RE: STATE SIGNIFICANT DEVELOPMENT (SSD 6962) AND CONCEPT PLAN MODIFICATION (MP09_0099 MOD4) – RESPONSE TO SUBMISSIONS

Response from Blacktown City Council to letter from Mirvac dated 29th September 2015
Civil / Stormwater Responses to SS 6962 BCC Conditions – 60 Wallgrove Road, Eastern Creek

Figure 2: Stepped retaining wall construction

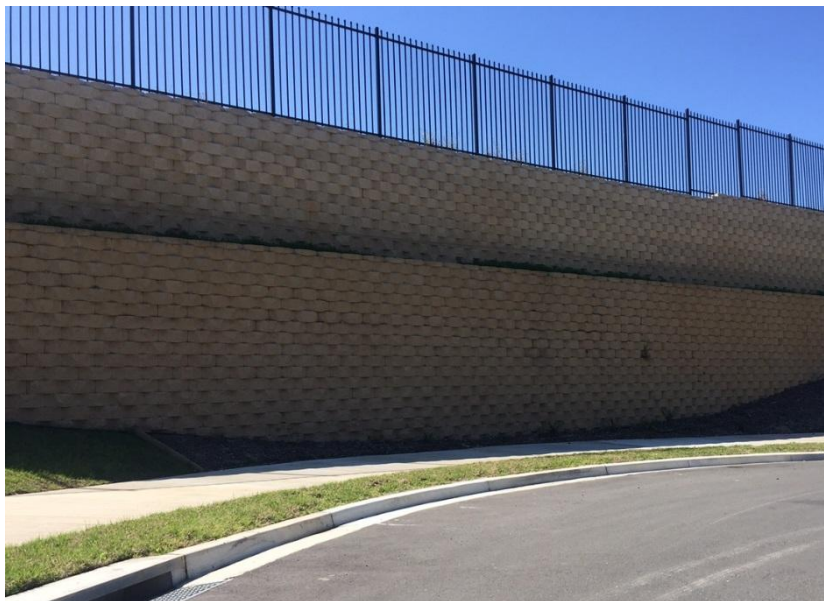
- 5.2. Council requested that retaining walls should be in maximum 2 metre high sections and stepped with 1 metre wide minimum planting bays.**

Mirvac notes that Council's concerns relate only to a relatively small section of retaining wall proposed along the northern boundary adjacent to Warehouse 3. Notwithstanding the above, we note that that Council's request for maximum 2 metre high retaining walls is inconsistent with the Blacktown City Council DCP (2015) and the existing Urban Design Guidelines.

Generally, the proposed retaining walls vary between 0.65m to 2.0m along the northern boundary adjacent to Warehouse 1, and between 0.0m to 2.6m along the western boundary adjacent to Warehouse 3. A retaining wall greater than 3m is proposed north of warehouse 1, to accommodate the existing stormwater culvert invert level.

Further to our response to item 2.1 above, Mirvac believes that providing a deep soil zone at the base of a single retaining wall will achieve a better visual screening outcome, by being able to accommodate mature trees in a deep soil zone rather than what could otherwise be planted within stepped retaining wall planting bays, which only provide for smaller shrubs due to the limited capacity in terms of soil volume and depth within the retaining wall.

Poor outcomes of stepped retaining wall designs which provide for insufficient landscaping can be identified throughout other nearby industrial developments (refer Figure 2 below). Mirvac will invest significant capital to ensure the proposed retaining wall design and landscaping strategy will achieve a superior long term visual screening outcome, and satisfies the objectives of the Urban Design Guidelines.
